MAINE TURNPIKE AUTHORITY

ADDENDUM NO. 4

CONTRACT 2022.07

INTERCHANGE IMPROVEMENTS

TYPICAL SECTIONS 2

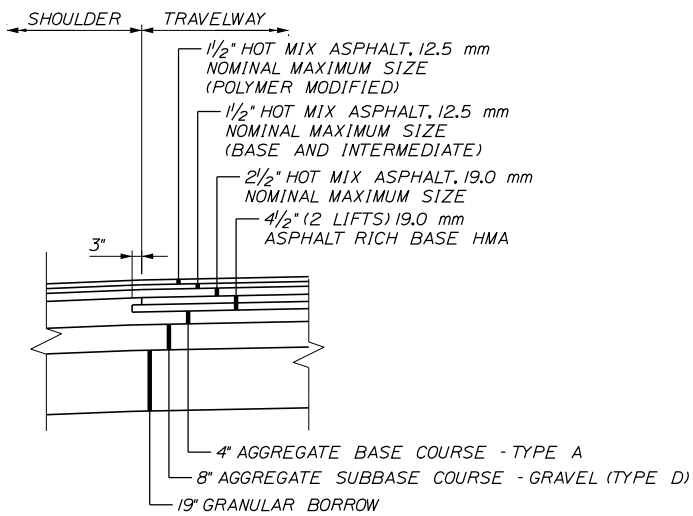
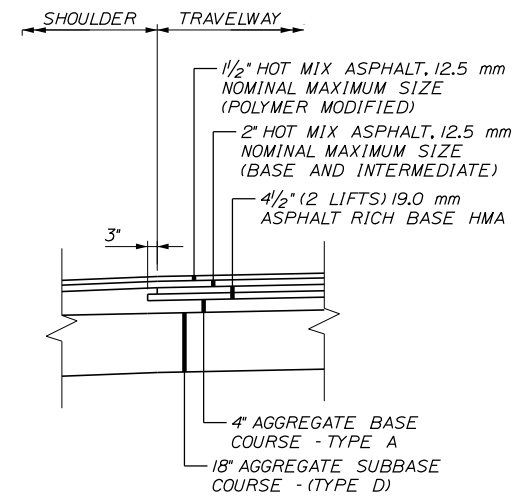
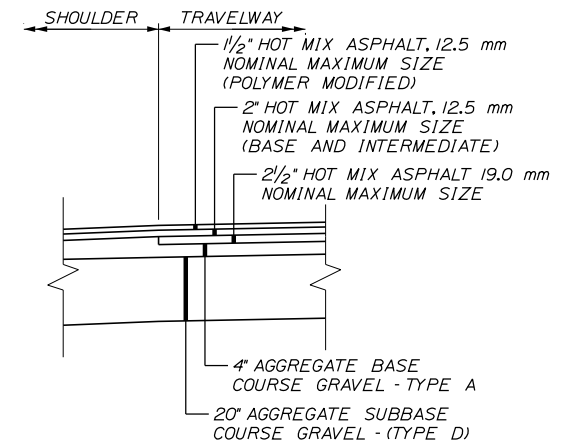
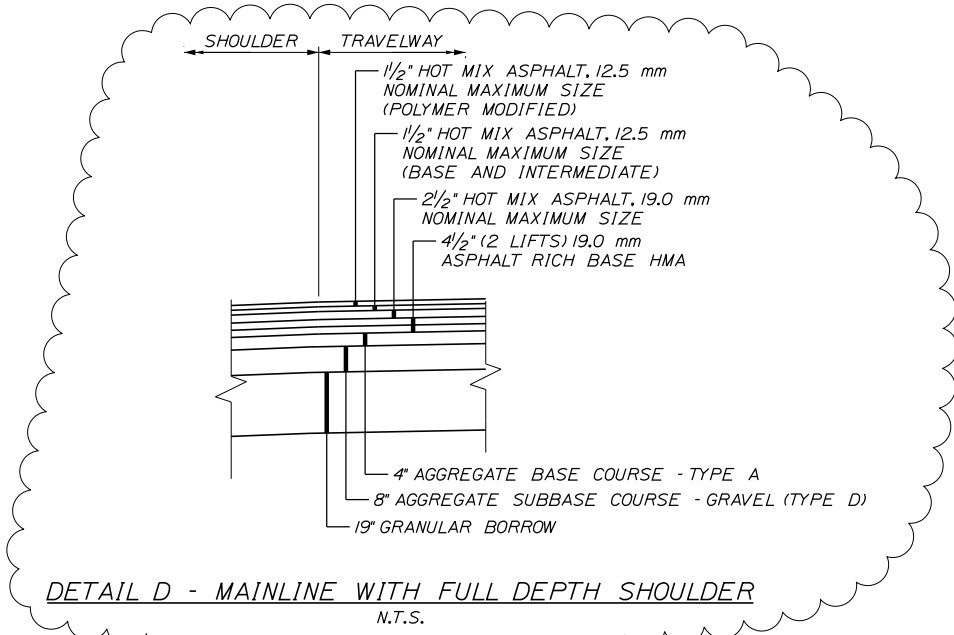
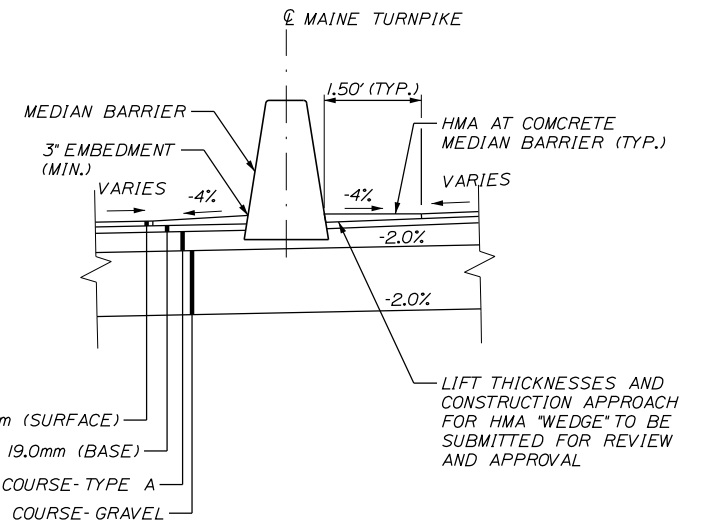
- Plan Sheet 13 of 735, TYPICAL SECTIONS 2, has been deleted in its entirety and replaced with Plan Sheet 13 of 735, included in this addendum.
- Plan Sheet 19 of 735, TYPICAL SECTIONS 8, has been deleted in its entirety and replaced with Plan Sheet 599 of 735, included in this addendum.

Answer: The quantities for Item 403.2072 have been reviewed and are unchanged. However, Typical Section Sheets 13 and 19 of 735 have been updated in Addendum No. 4.

No.	Revision	By	Date
1	TYPICAL REVISIONS	JRH	11/22

**INTERCHANGE IMPROVEMENTS
SACO (EXITS 35 & 36)
POWER AND COMMUNICATION PLAN 6**

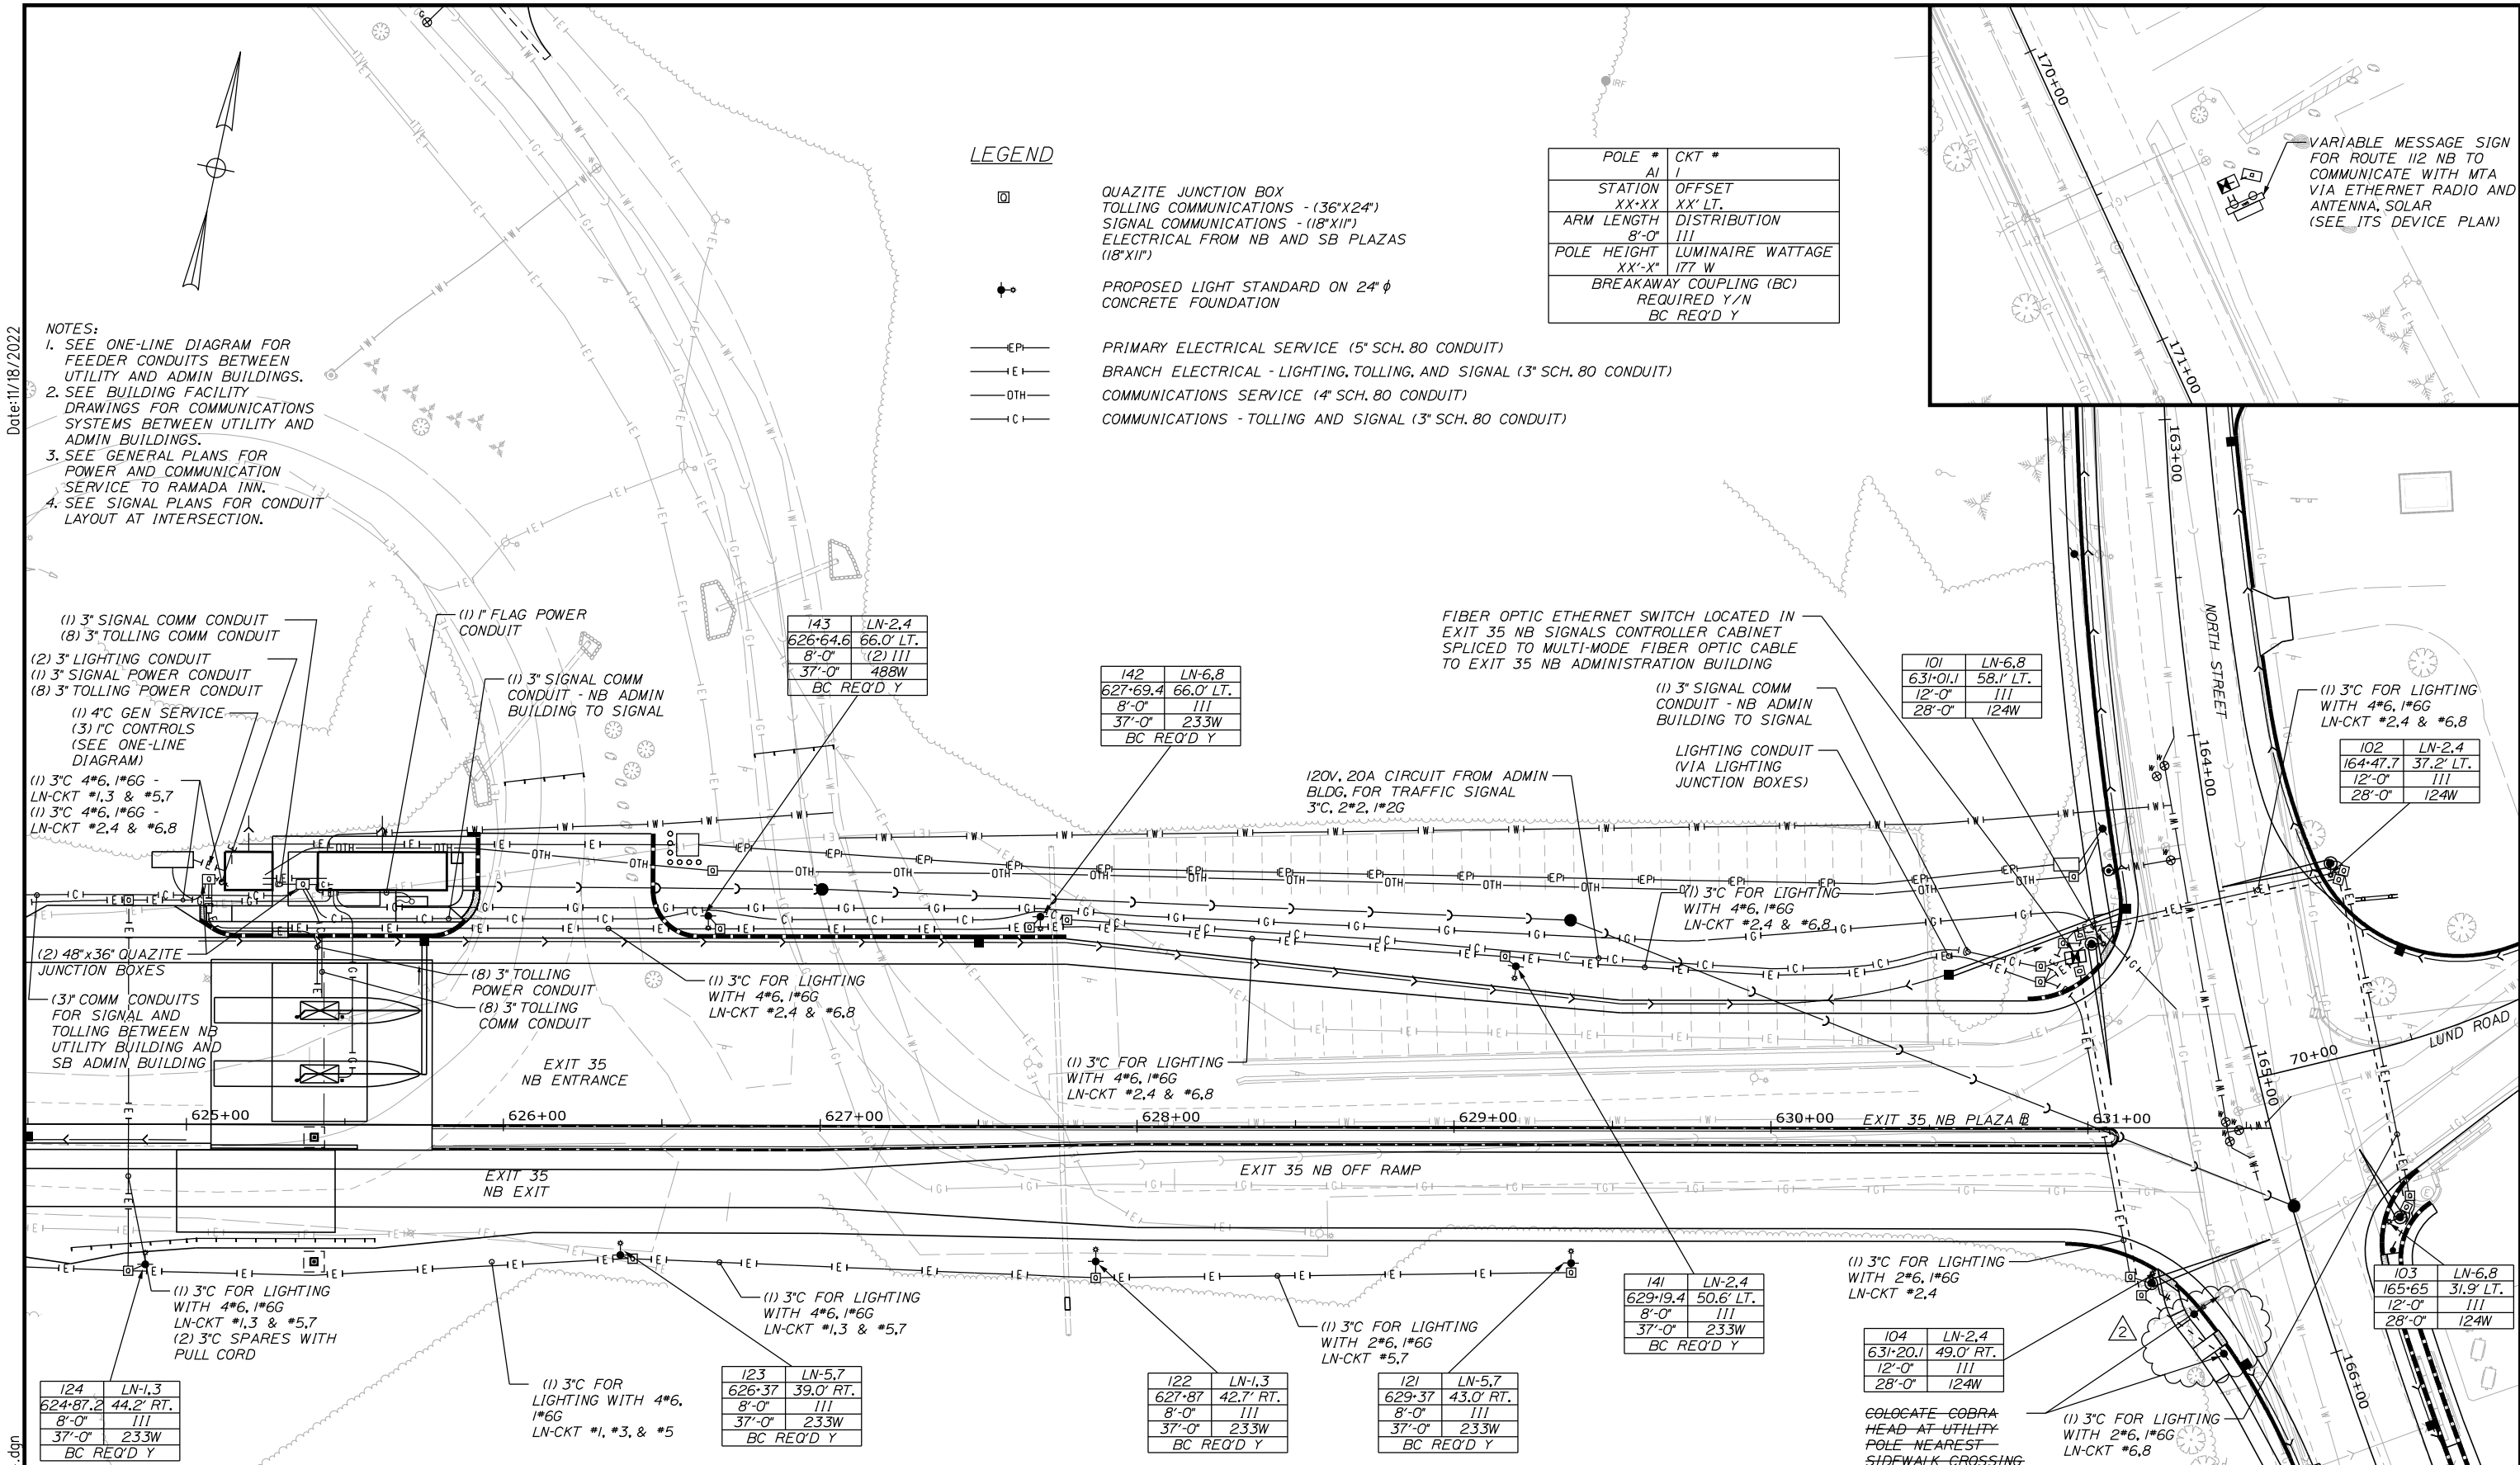
- Plan Sheets 252, 255, & 256 of 735, POWER AND COMMUNICATION PLAN 6, 9, & 10, have been deleted in its entirety and replaced with Plan Sheets 252, 255, & 256 of 735, included in this addendum.

No.	Revision	By	Date
1	NOTE REMOVAL	JRH	10/22
2	REVISED LIGHT LOCATION	JRH	11/22

SIGNAL PLAN 2

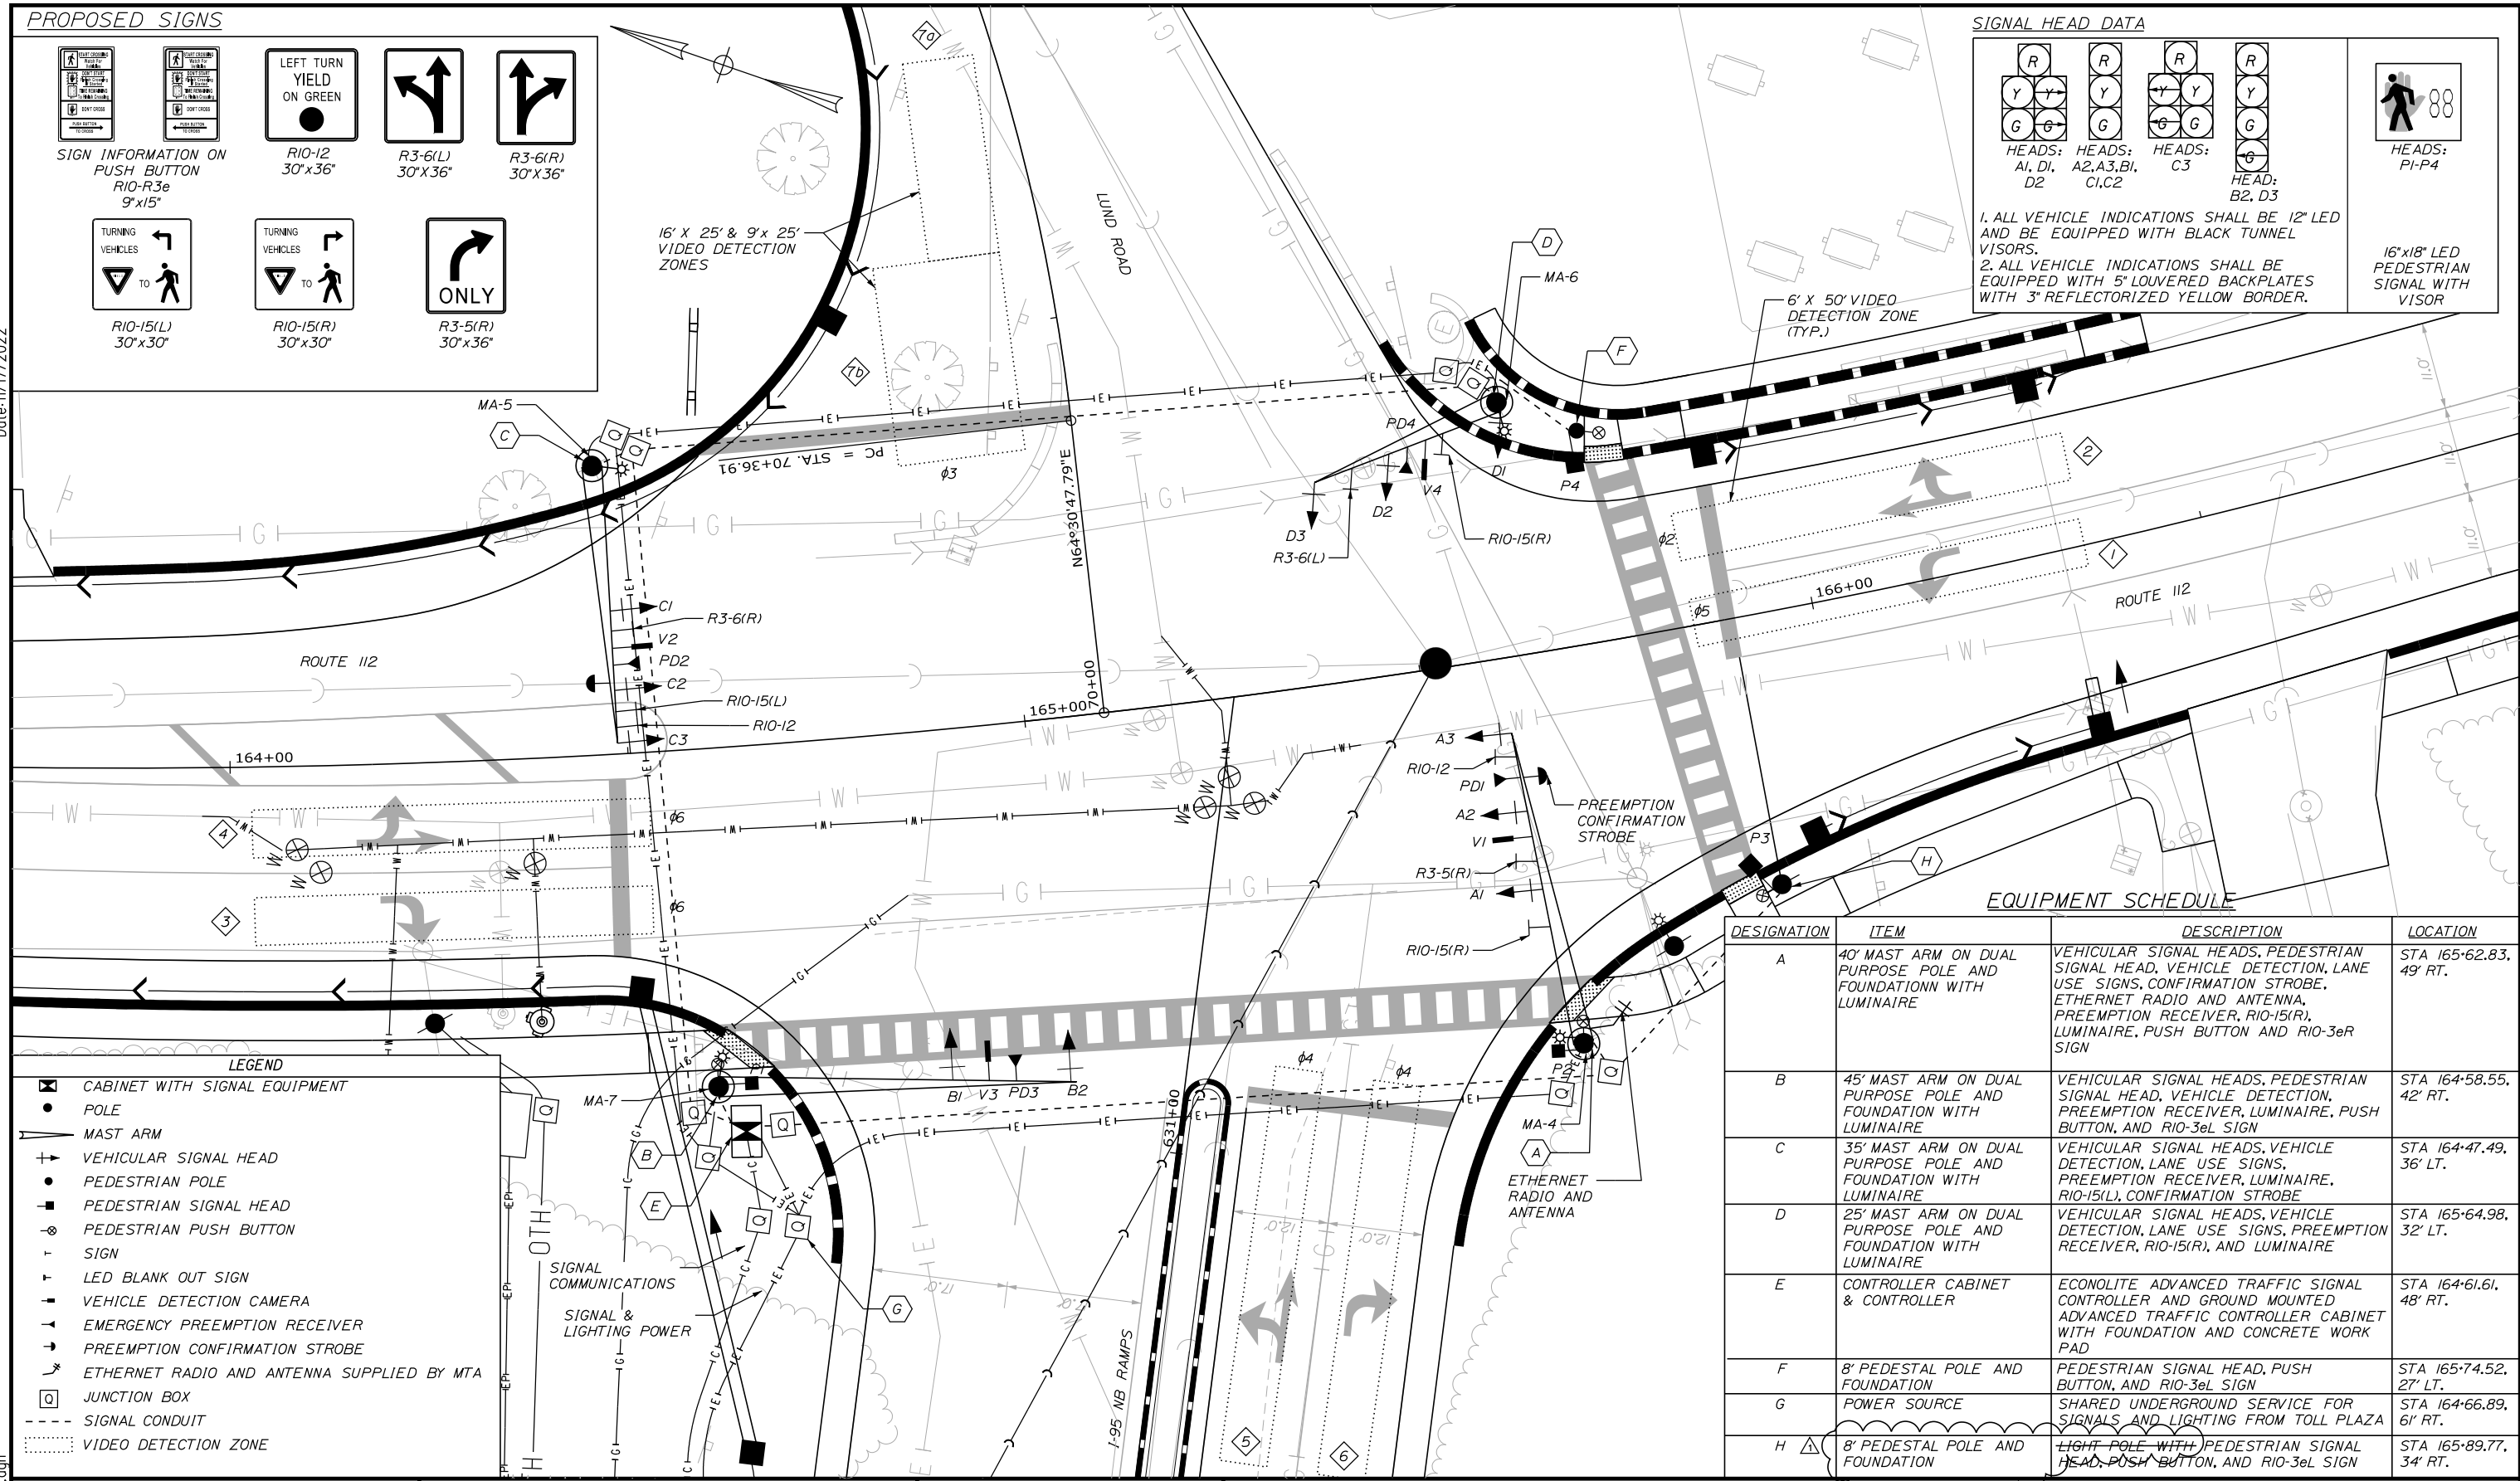
- Plan Sheet 268 of 735, SIGNAL PLAN 2, has been deleted in its entirety and replaced with Plan Sheet 268 of 735, included in this addendum.
- Plan Sheet 269 of 735, SIGNAL NOTES, has been deleted in its entirety and replaced with Plan Sheet 269 of 735, included in this addendum.

No.	Revision	By	Date
1	REVISED NOTE	JRH	11/22
